DIFFERENCES BETWEEN SANDIA AND  
NUMARC ANALYSES OF DECAY HEAT REMOVAL  
RELATED RISK FOR POINT BEACH

SUBJECT: DIFFERENCES BETWEEN SANDIA AND NUMARC ANALYSES OF  
DECAY HEAT REMOVAL RELATED RISK FOR POINT BEACH

PURPOSE OF MEETING: NUMARC will present additional information requested by the NRC Staff and by Sandia personnel regarding the NUMARC analysis of decay heat removal related risk at the Point Beach Plant. Subject areas to be emphasized will be those agreed upon at the earlier 2/23/88 public meeting on the same subject with Sandia and NUMARC.

Figure 1

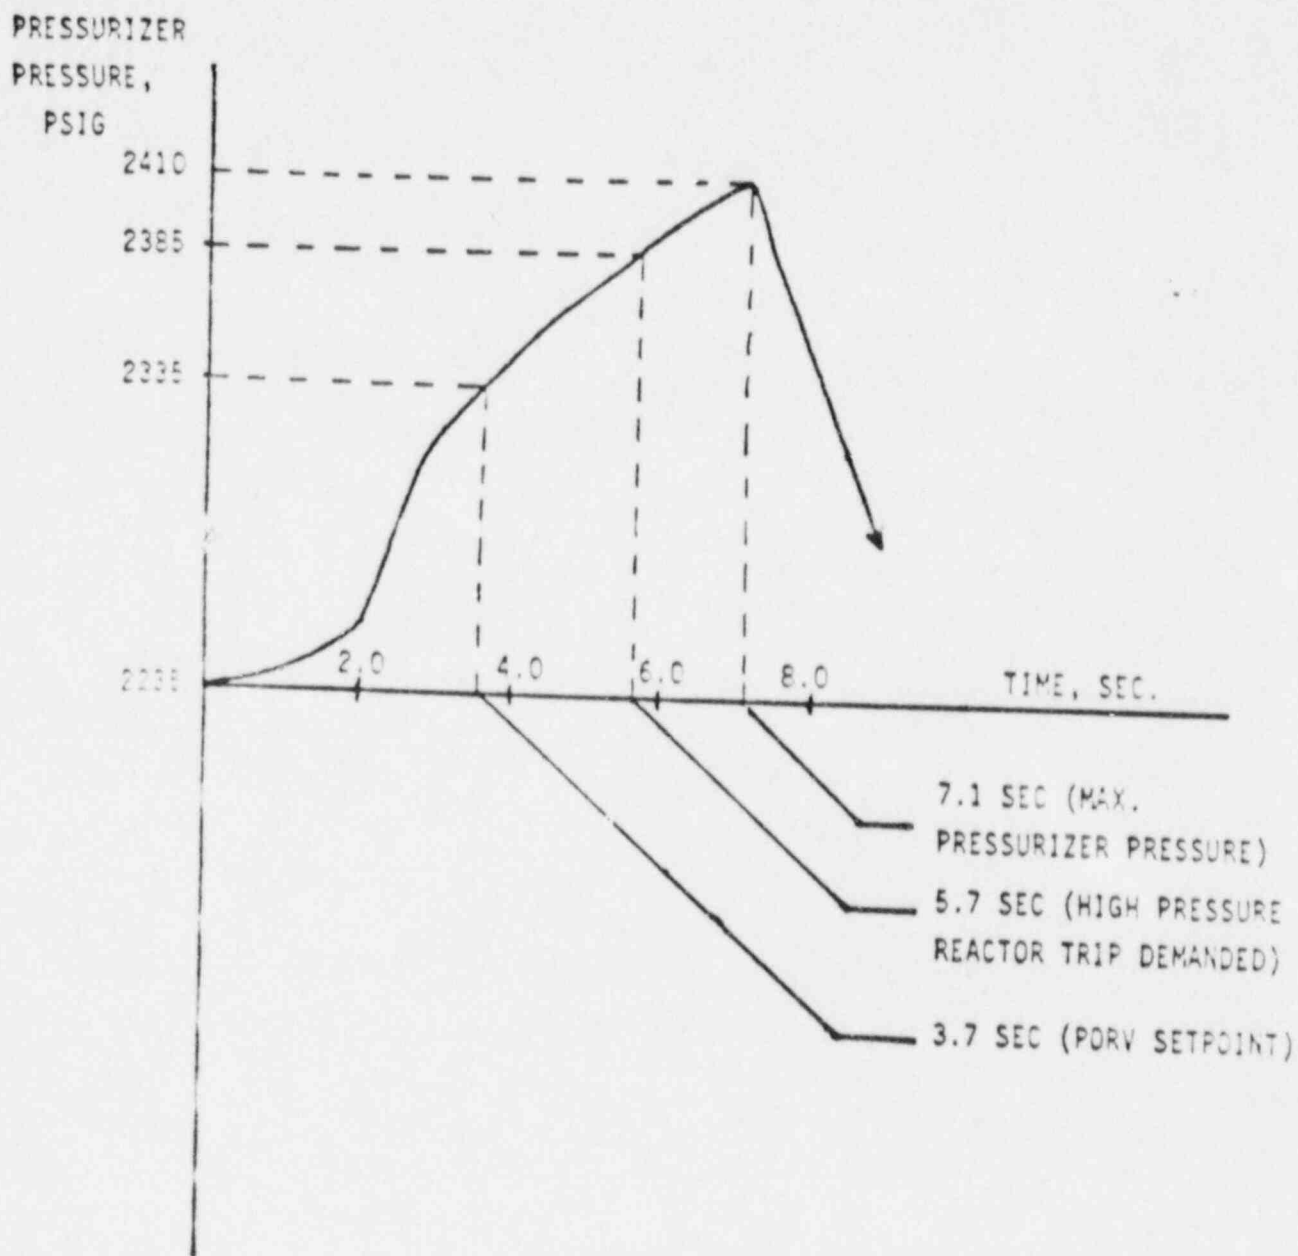
Response (a): Opening of pressurizer safety valves during power operation is a very rare event on Westinghouse PWRs. The reasons are . . . . (1) Westinghouse used a very conservative approach for primary pressure relief; and (2) transients requiring relief are much less frequent than commonly assumed. Based on engineering judgment and estimates of knowledgeable Westinghouse engineers, we estimate the rate of pressurizer safety valve opening (during power operation) to be roughly 0.01 safety valve openings/reactor year. This is in sharp contrast to the NRC Case Study assumption of approximately 0.5 safety valve openings per reactor year due to an assumed 7 pressure transients per reactor year with a 7% chance of opening the safety valves in each. This difference of a factor of 50 can be very important in arriving at an unisolatable small LOCA frequency (should a safety valve fail to reclose there are no back-up block valves as in the case of the PORVs) and is due to several causes as follows:

Fig 1 A simple arithmetic average of all the various age factors.

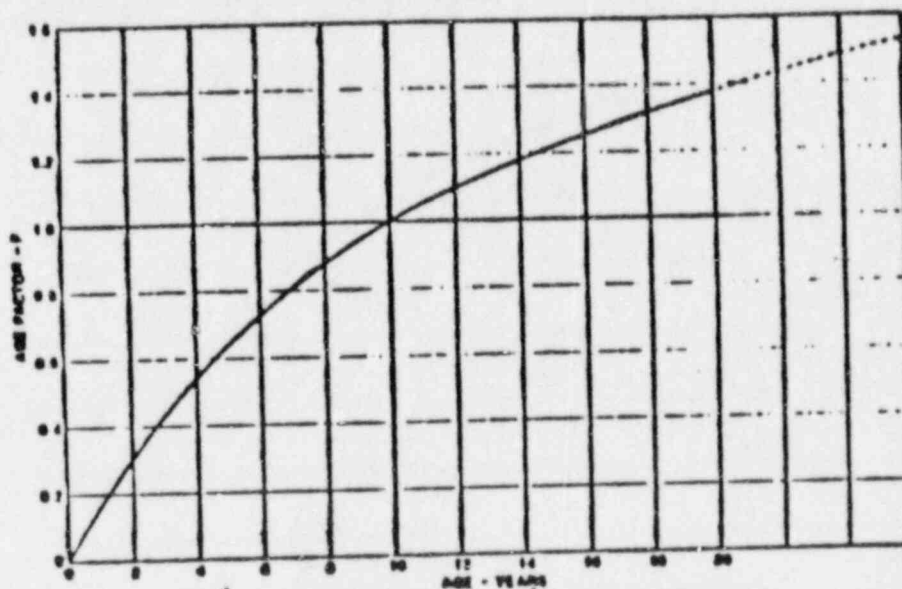
To account for age related effects, the factor  $F$  is applied according

Extrapolation of Figure 1 to 40 years, yields  $F = 2$ .

Fig 2 Hypothetical design learning curve

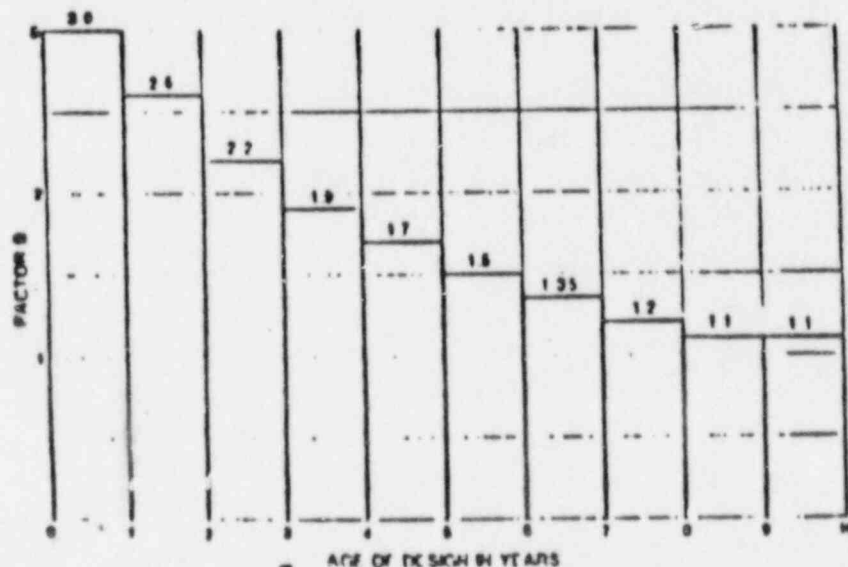
To account for design experience and other learning-curve effects, Thomas suggests that factors related to the technology as a whole may be neglected entirely, or they may be assumed to be incorporated within the global statistics for P1 (i.e., within the product QeF). To account for the age of the design of the specific plant, the factor B is applied according to Figure 2 which is reproduced from Reference 1.

Note that the curve asymptotically approaches unity, where age is measured from the start of service. Because the curve is hypothetical in nature, Thomas notes that it must be used with caution. Nevertheless, it appears fair to say that older, established designs should be expected to have failure rates that are average as compared to newer untried designs. After 10 years service,  $F^{-1}$ .

Figure 4.2 Location of the Sample Sites in the EUS

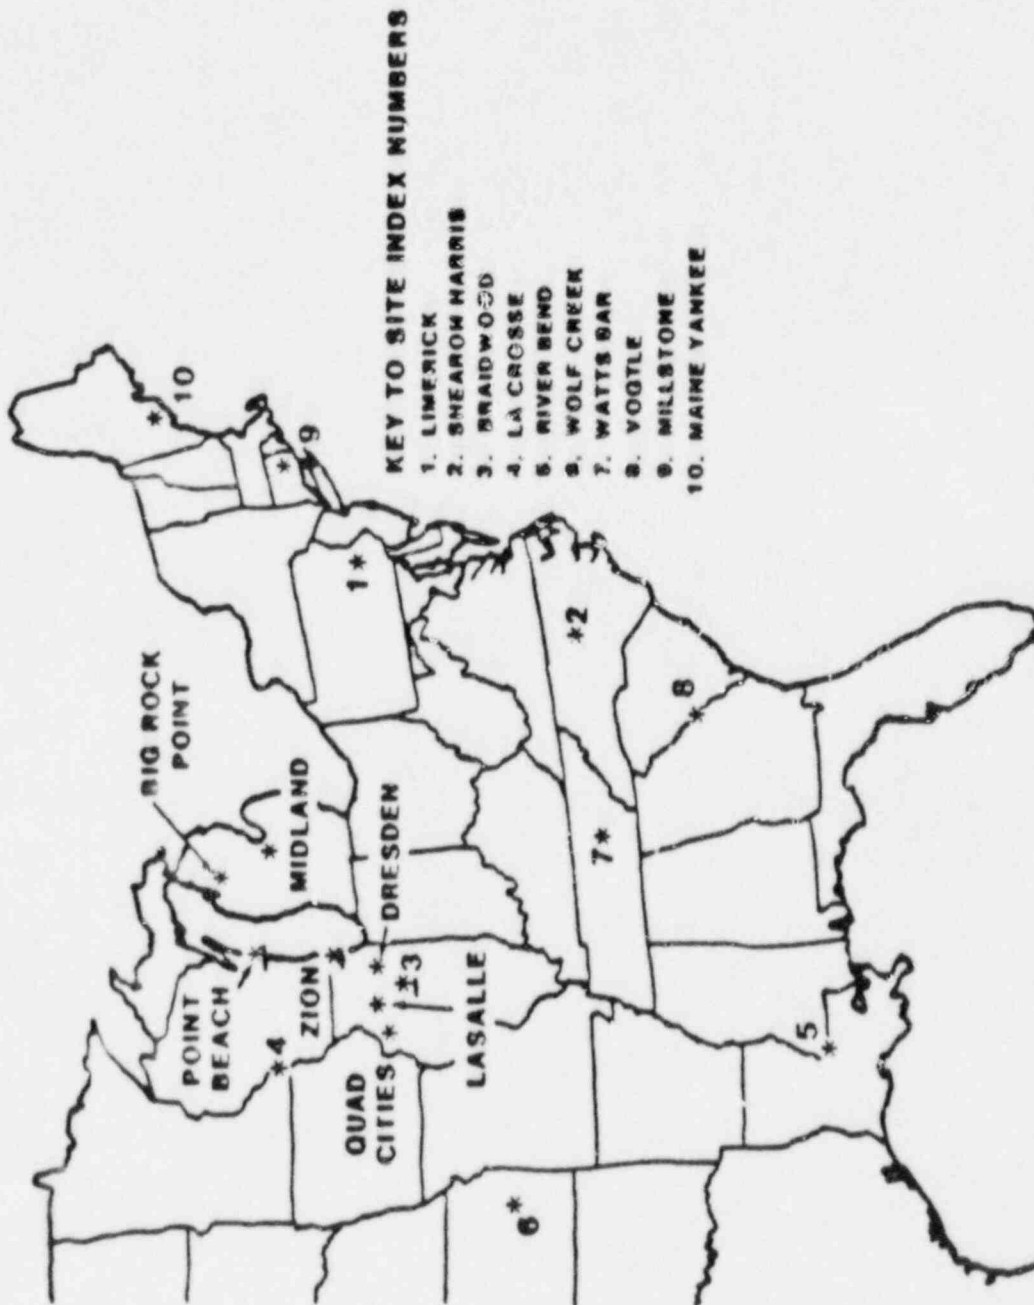
Response: The EPRI/WOG comment on the Point Beach seismic hazard curve accepts the method used to prescribe the curve as reasonable. It was suggested that the prescribed curve is conservative by a factor of two to five based on recent computations at the Braidwood site by LLNL and EPRI. The Braidwood site is in the same tectonic region with Zion and Point Beach and also is a reasonable basis for comparison. The comparison shows a factor of about 10 at low acceleration level (0.1g) increasing to more than a factor of 40 at very high acceleration level (1.0 g). A basic assumption made in prescribing the Point Beach seismic hazard curve is that its slope is the same as the Zion hazard curve. The Braidwood comparison shows divergence between the LLNL and EPRI results with increasing acceleration level. Moreover, the probability of exceeding the Braidwood SSE is about a factor of ten lower than the assumed  $2.5E-4$  per year assumed for Point Beach. Thus considering local site amplification, the prescribed Point Beach hazard curve should be considered conservative.
